Technical Service Bulletin

MODEL(S)
AFFECTED: **Tennant 5680**

SUBJECT: Actuators being damaged due to improper installation/adjustment.

FIG. 1

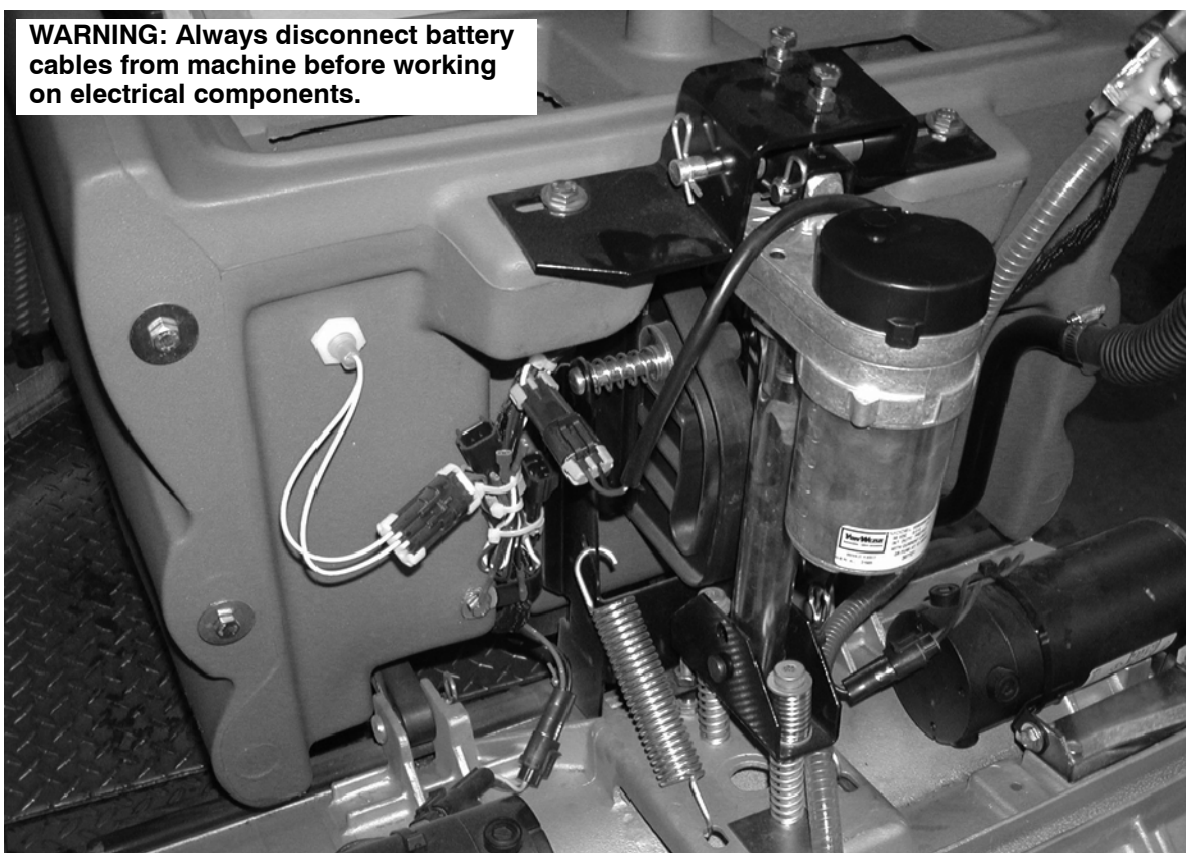
NOTES: Kit number 9003318. The Instruction Bulletin for this kit is IB 340845.
Refer to IB 340845 for instructions how to properly install and adjust the actuator (Tennant part number 397721) on 5680 machines. The actuator can be easily damaged if it is not installed and adjusted **as instructed in the IB.**
Questions, contact the Tennant Customer Service Department at (800) 553-8033 or (763) 513-2850.

PURPOSE: Properly install/adjust actuator.
